CARC Injector Valve Oil Cup Lubricator CARC Cup Holder & Bracket

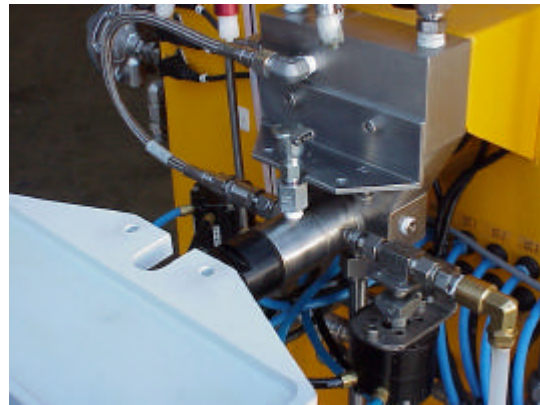
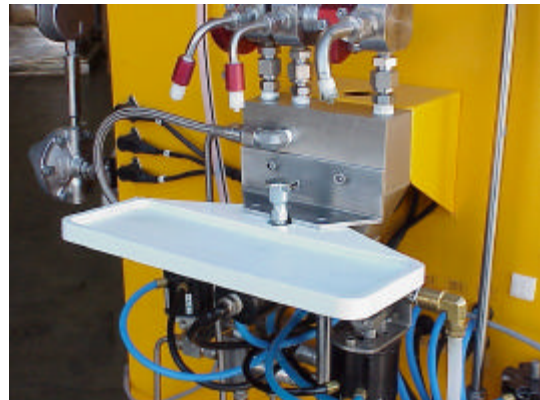
New Design permits easy access for valve lubrication and valve maintenance

Remove old Cup Holder and mounting Bracket
Reorient injector valve oil port to the vertical position (Valve must be disassembled).

Install new Cup Holder (003-CH-PP-029) and Cup Holder Bracket (003-CB-AL-030). Mount new Oil Cup (005-PR-OC-254). Slotted Cup Holder can be easily removed for convenient access to service injector valve.

New Oil Cup location provides more convenient access for regular lubrication of the catalyst injector valve.
